AMENDMENT TO THE DRAWINGS

REMARKS

**FIG - 10A****FIG - 10B**

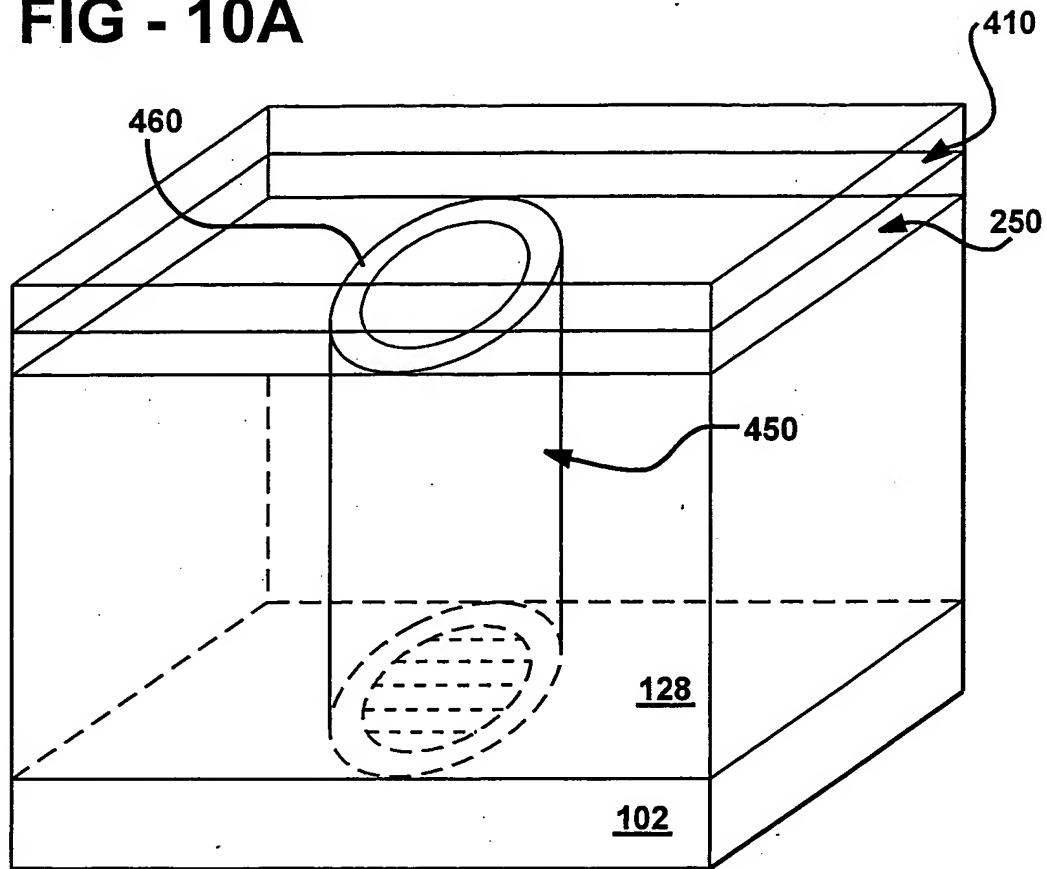
Figure 10B has been amended. Support for the amendment is found in Figure 10A and from the specification on page 33, line 15 to page 34, line 5.
